**METROPOLITAN GOVERNMENT OF NASHVILLE AND DAVIDSON COUNTY**

**STAFF RECOMMENDATION**

**2220 Grantland Avenue**

**Application:** New Construction—Additions and Outbuilding

**1-PROPOSED SITE DIAGRAM**  
SCALE: 1"=20'

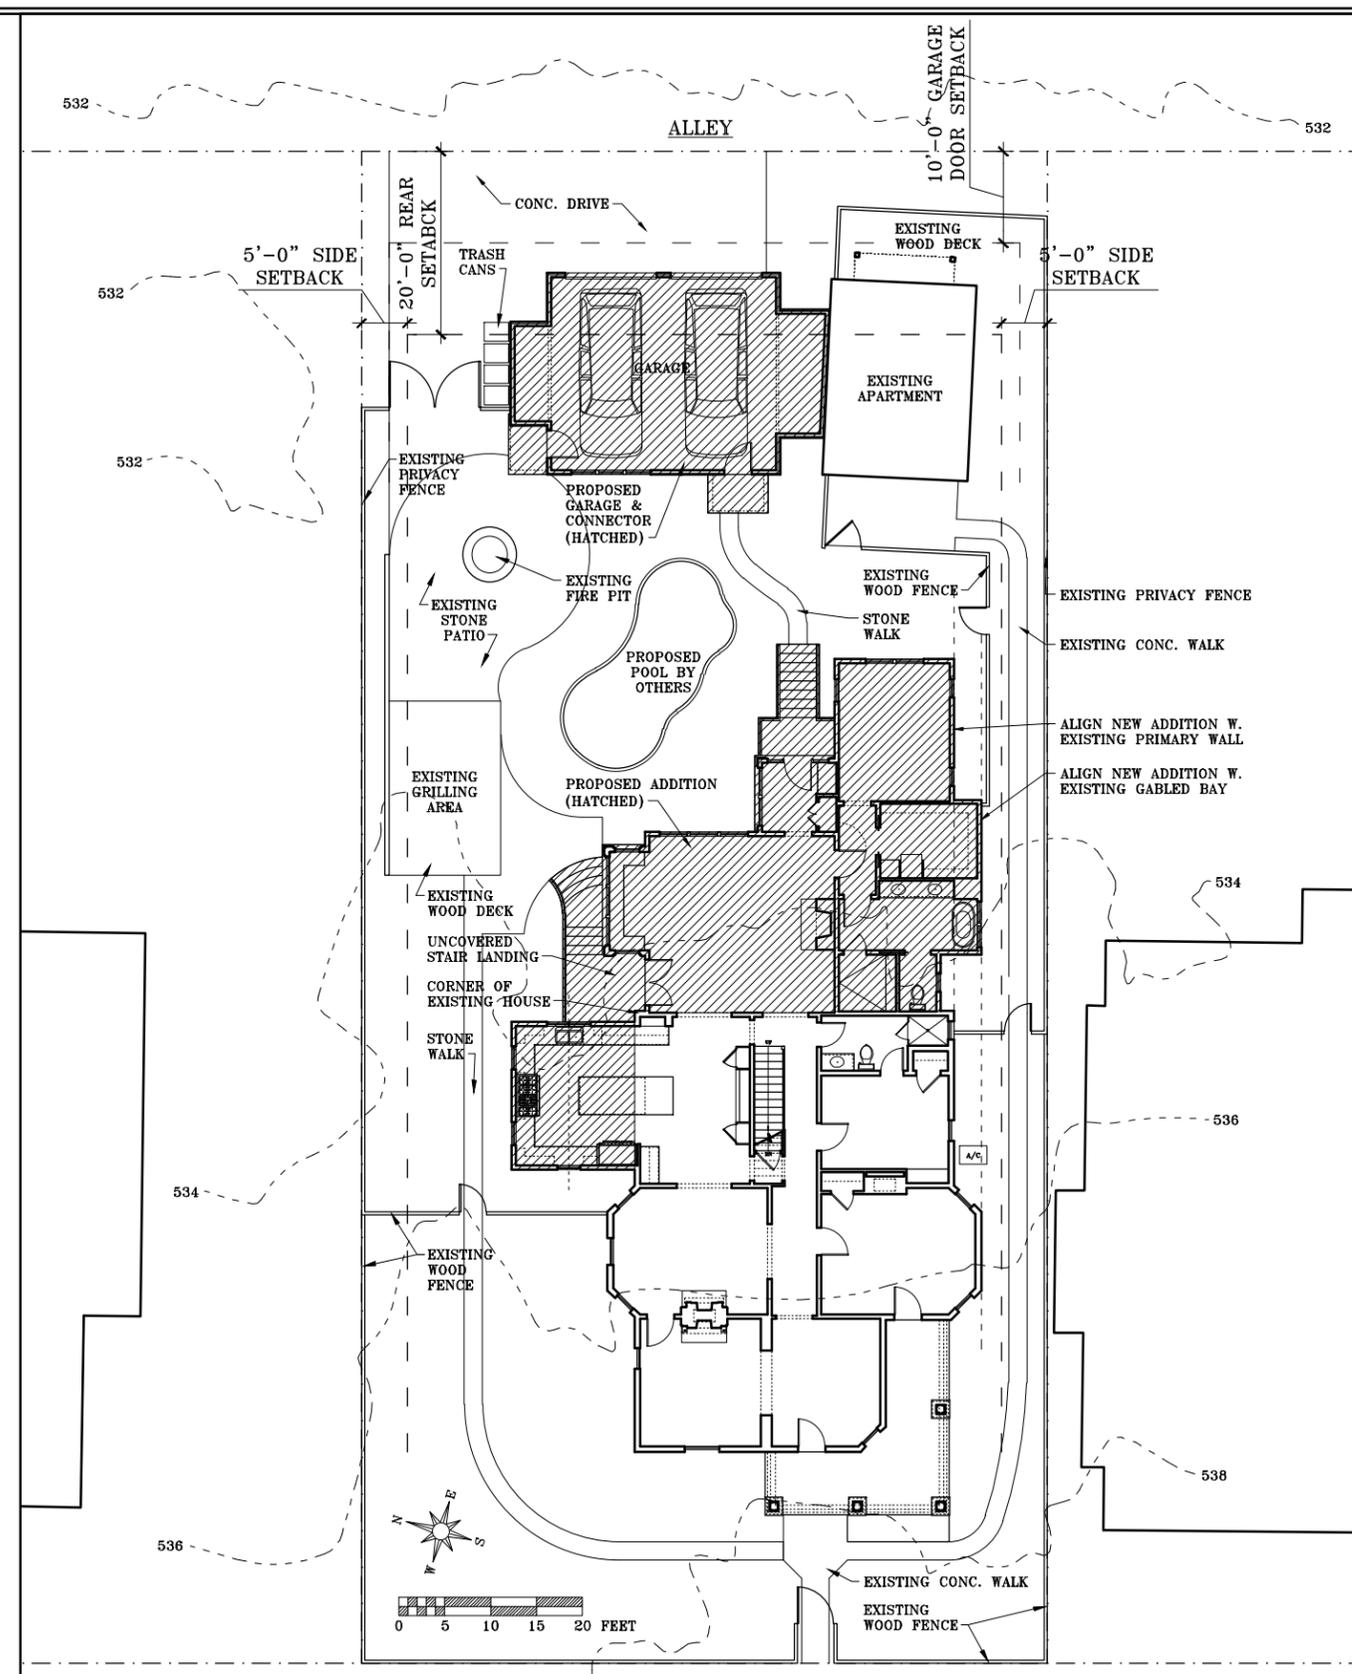
The lot at 2220 Grantland is seventy-five feet (75') wide, approximately fifty percent (50%) wider than most other lots on the street.

Section III.B.1.a of the design guidelines states that “generally, an addition should be situated at the rear of a building in such a way that it will not disturb either front or side facades.” In some instances, the Commission has concluded that side additions may be appropriate for corner lots or lots more than 60’ wide. The lot at 2220 Grantland Avenue is seventy-five feet (75’) wide, and the house is shifted toward the right side of the lot.

1-FIRST FLOOR PLAN  
 SCALE: 1/8"=1'-0"

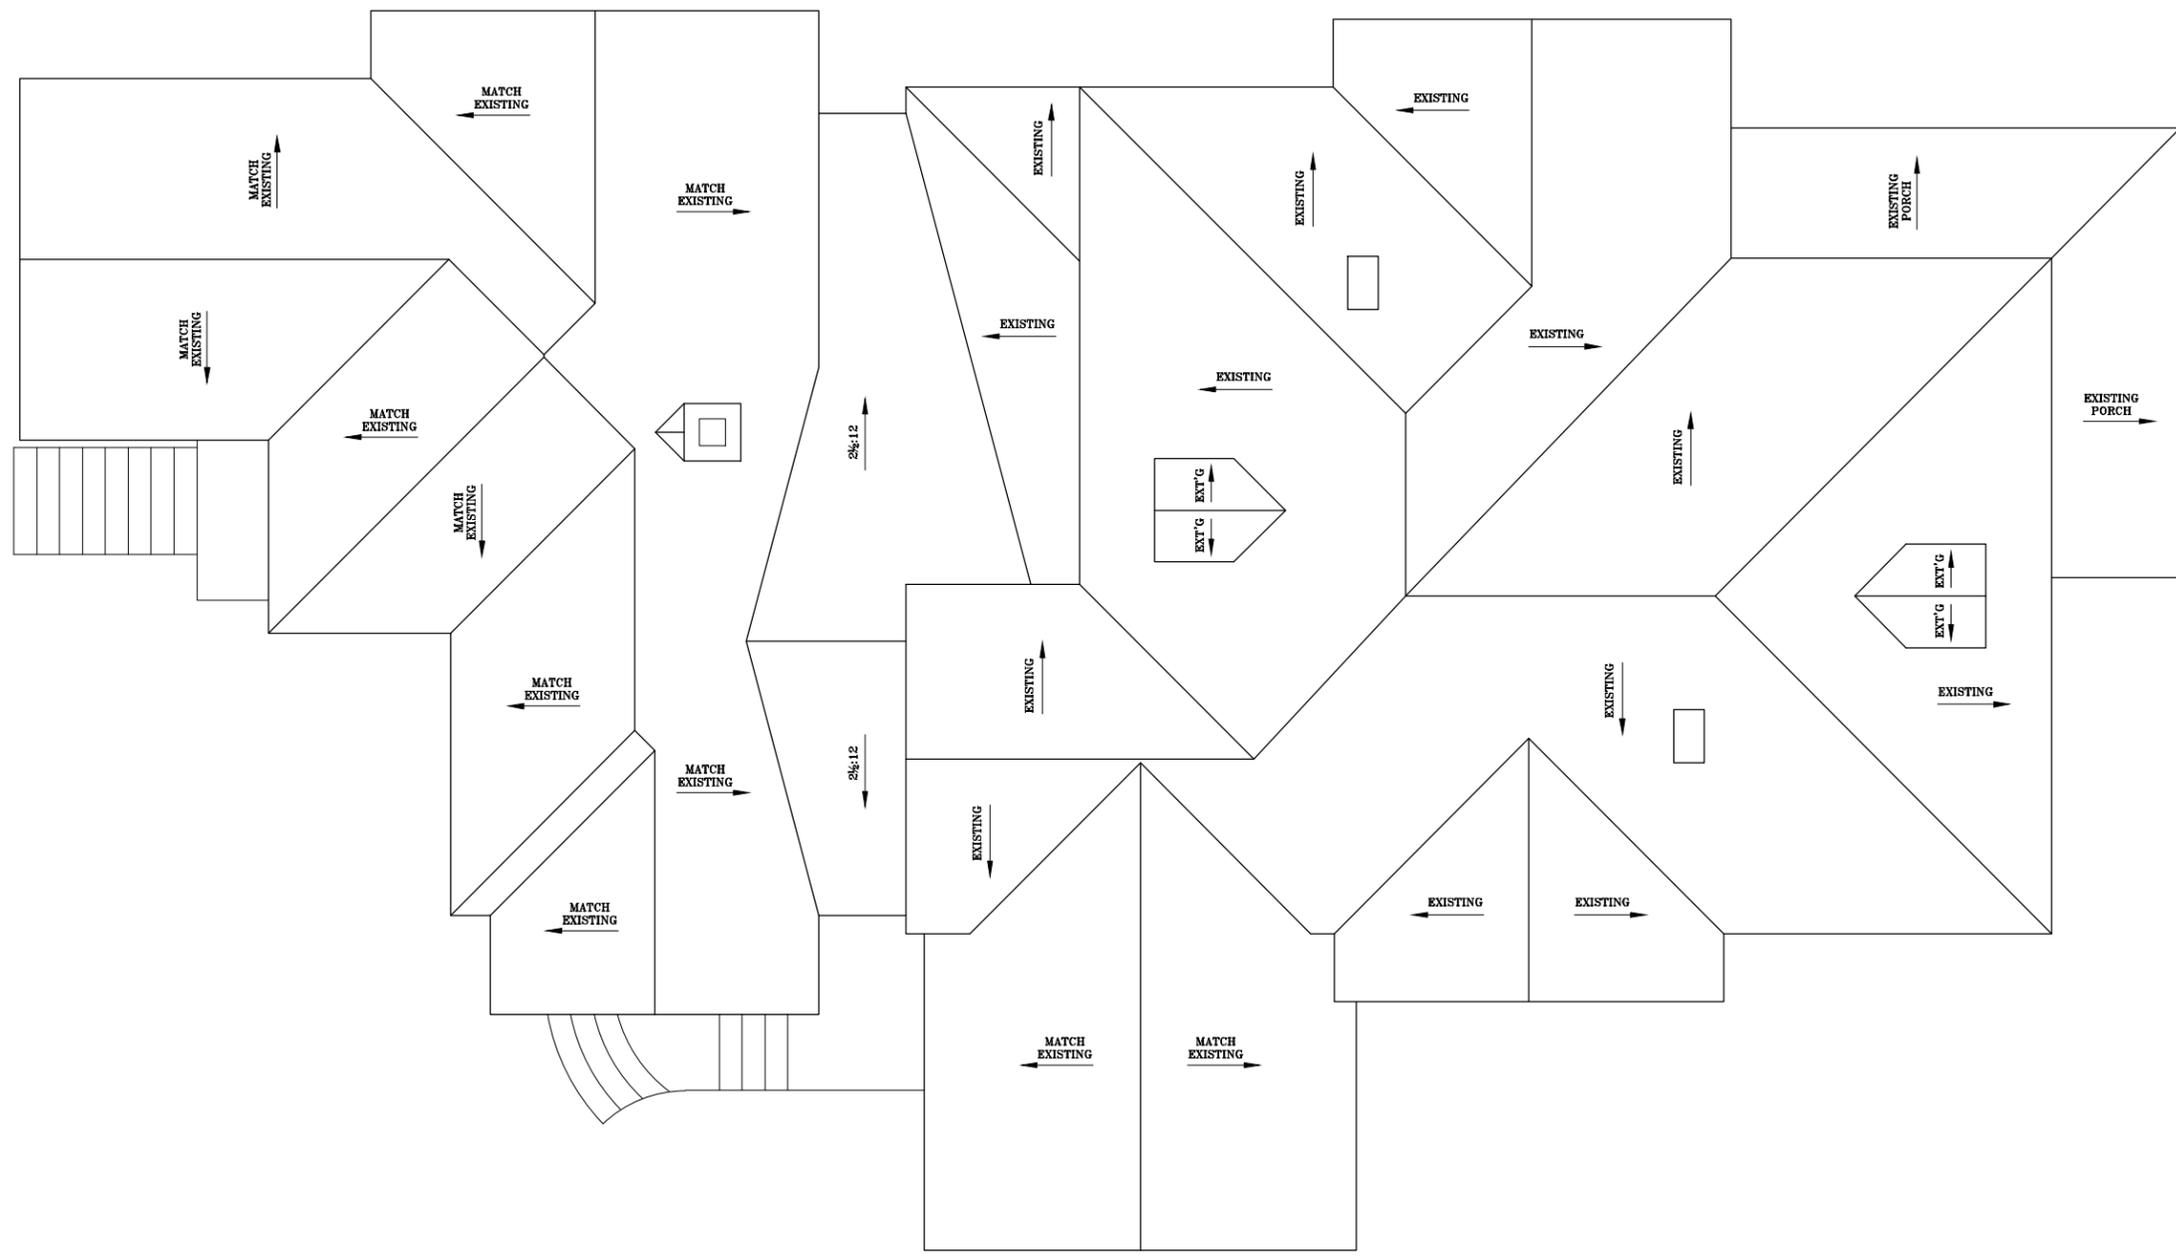
Location, Design (Rear Addition): The rear addition will be one story tall, stepped in fourteen inches (14") from the rear corner of the house on the left side and eighteen inches (18") on the right. As the addition extends back it will step out to align with the primary wall of the house on the right side, and will step further in on the left, with projecting bays on both sides matching the width of bays on the historic house.

Height, Scale (Rear Addition): As the rear addition extends back, after stepping in for a span of six feet (6’), it will step out to align with the primary wall of the house on the right side, and after eighteen feet (18’) it will step in twelve feet (12’) further on the left. There will also be projecting bays on both sides matching the width of bays on the historic house. The eave height of the rear addition will match the original building, and the roof will have a peak height more than two feet (2’) lower than the original hipped roof, with the majority of the roof at or below the height of the smaller projecting gables on the historic house.

Height, Scale (Side Addition): The side addition will originate approximately thirty-one feet (31’) back from the front wall of the house, extending thirteen feet, four inches (13’-4”) to the left side. This is less than half of the width of the house, which is thirty-five feet (35’) for the primary building mass. The eave height on the side addition will be eighteen inches (18”) lower than the eaves on the historic house, and the roof ridge will be one foot (1’) lower. The lower heights help the side addition read as subordinate to the historic house.

Staff finds the location of the proposed rear addition and the general character of the design to be compatible with the historic house, and that it will meet sections III.B.1.a and III.B.1.d of the design guidelines for additions.

Staff finds the height and scale of the proposed rear addition meet sections III.B.2.a and III.B.2.b of the design guidelines.

Staff finds the height and scale of the proposed side addition are compatible with the historic house and meet sections III.B.2.a and III.B.2.b of the design guidelines.

1-REAR ELEVATION  
SCALE: 1/8" = 1'-0"

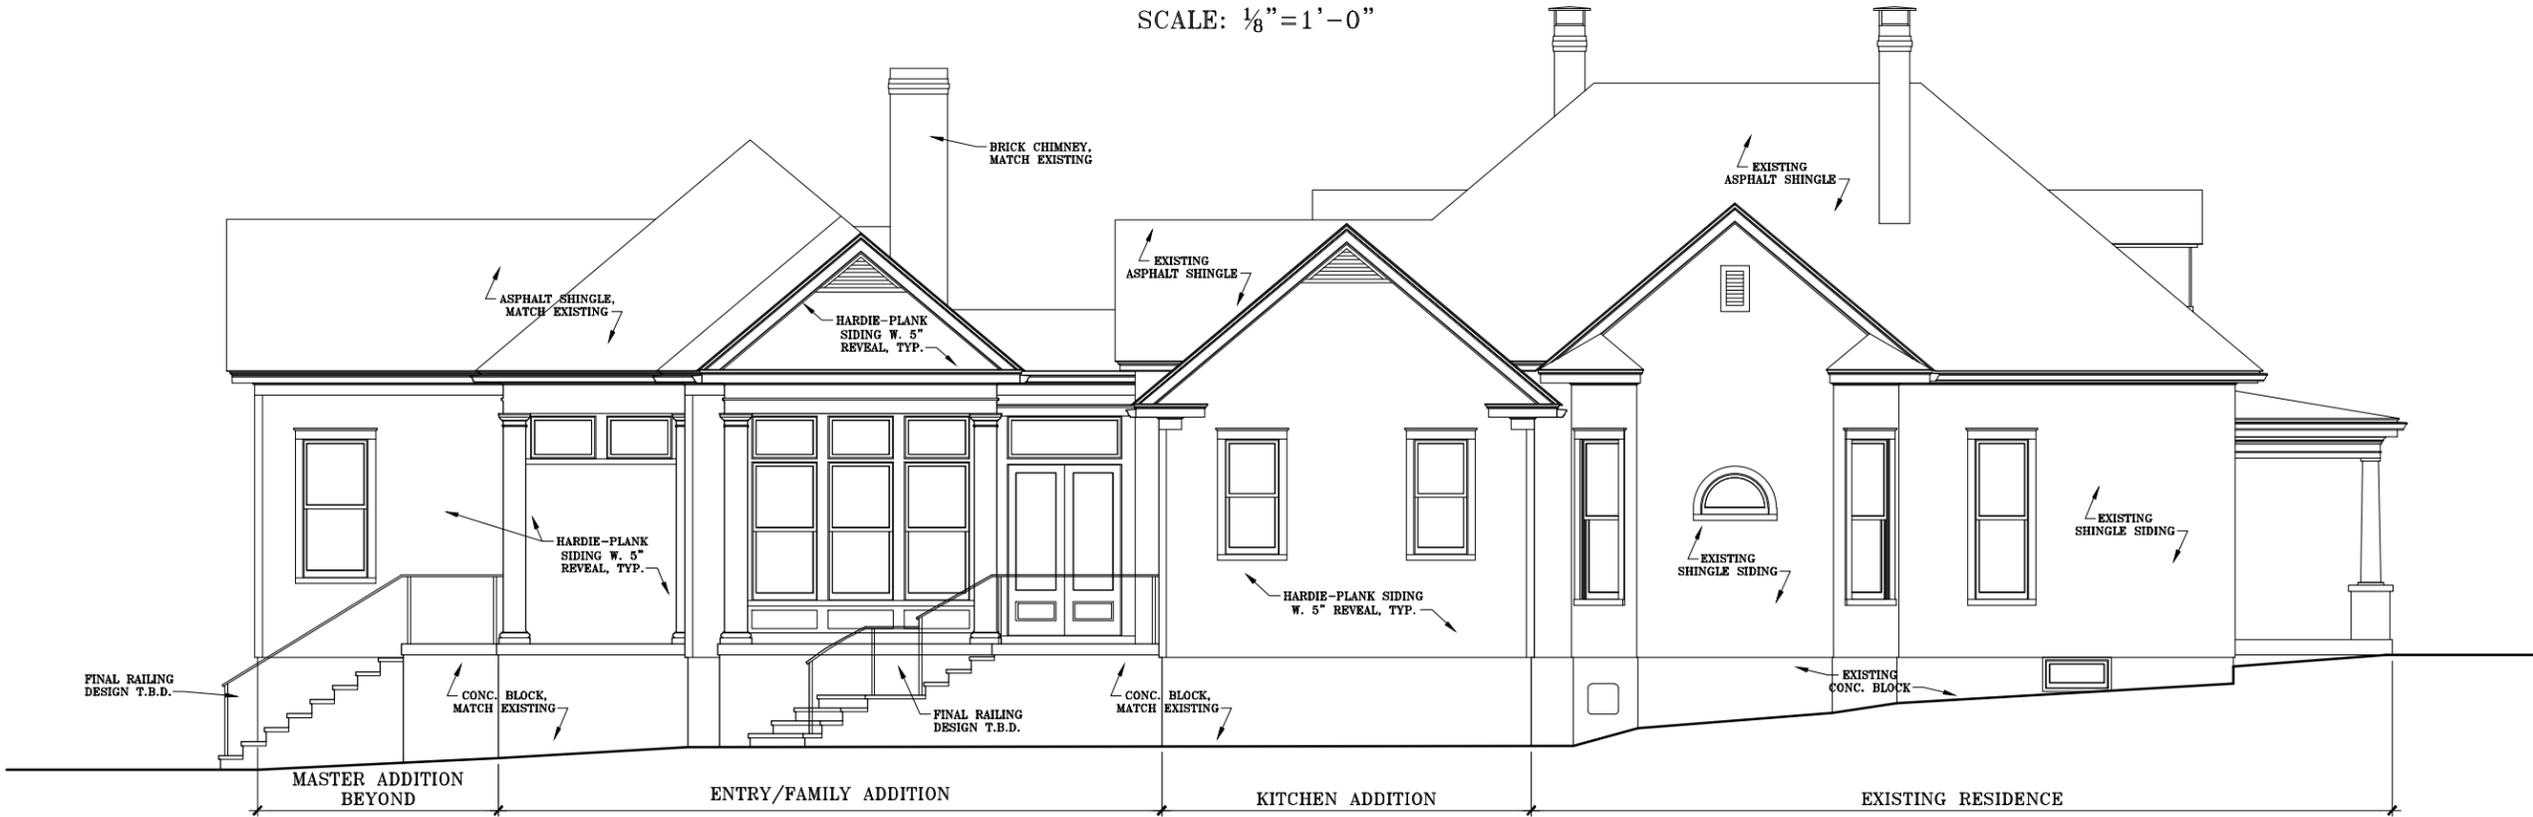
Materials, Texture, and Details and Material Color: The rear addition will have an asphalt-shingle roof and concrete block foundation to match the existing building. The walls will be clad with cement-fiber clapboard siding with wood or cement-fiber trim. The wood and door materials are not known at this time, nor is the material of a deck and handrail indicated on the plans.

**Proportion and Rhythm of Openings:** No changes to the window and door openings on the existing house were indicated on the plans, other than on the portion of the left side and the rear walls as described in the “Demolition” section above. The windows on the proposed addition are generally twice as tall as they are wide, consistent with the proportions of windows on the historic house. A pair of horizontal windows on the left elevation will be in a wall stepped in and obscured by the wider side addition, and there are no large expanses of wall space without a window or door opening.

With a condition that staff approves the window and door selections and the deck and railing material, staff finds that the proposal will meet sections III.1.B.c and III.B.1.e of the design guidelines for materials.

**1-GARAGE PLAN**  
 SCALE: 1/8" = 1'-0"

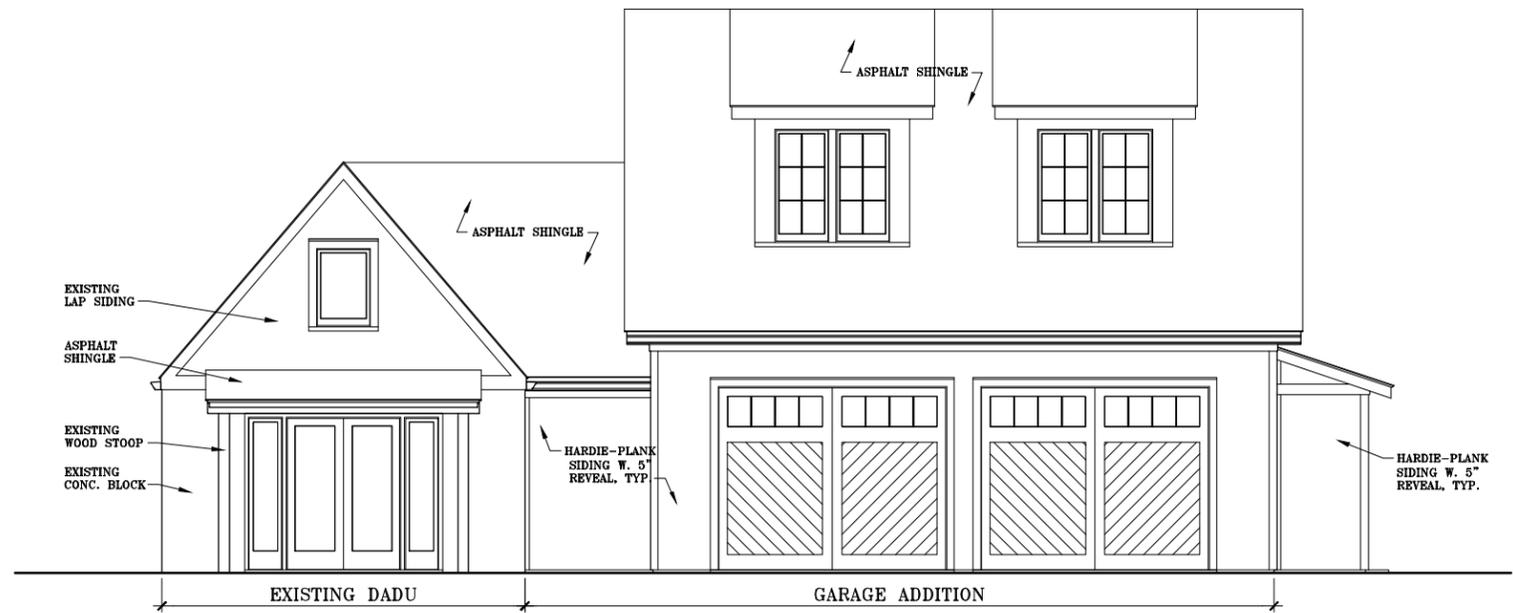
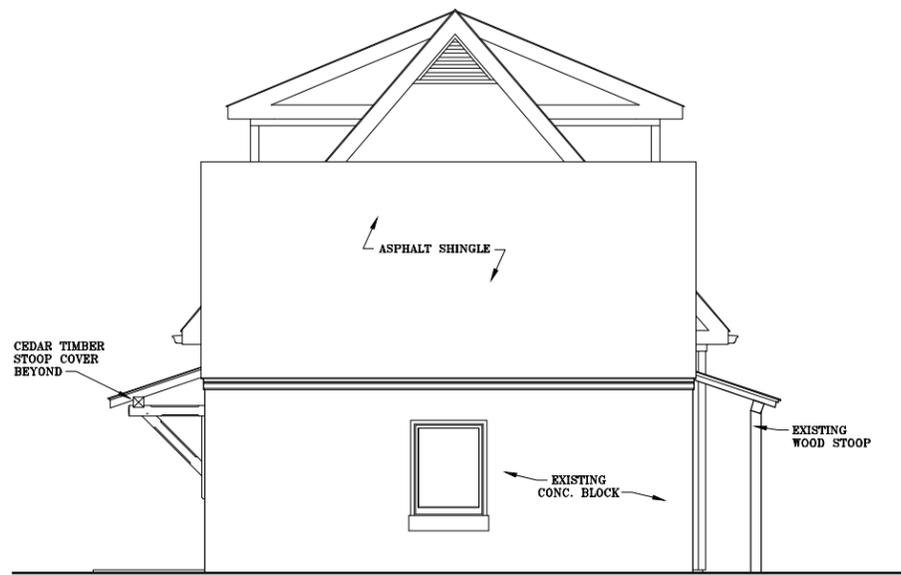
**Outbuilding, Detached Accessory Dwelling Unit:** The applicant proposes to construct a one and one-half story addition to the existing one-story outbuilding. The existing structure has a footprint of six hundred, sixty-one square feet (661 sq. ft.), and it has been used as an accessory dwelling since before the current DADU standards were adopted in 2011. The existing portion will remain and continue to be used as an apartment; the addition will be garage and storage.

Staff finds that scale, massing, and roof form of the outbuilding would meet section III.2.h of the design guidelines and the standards for detached accessory dwelling units.
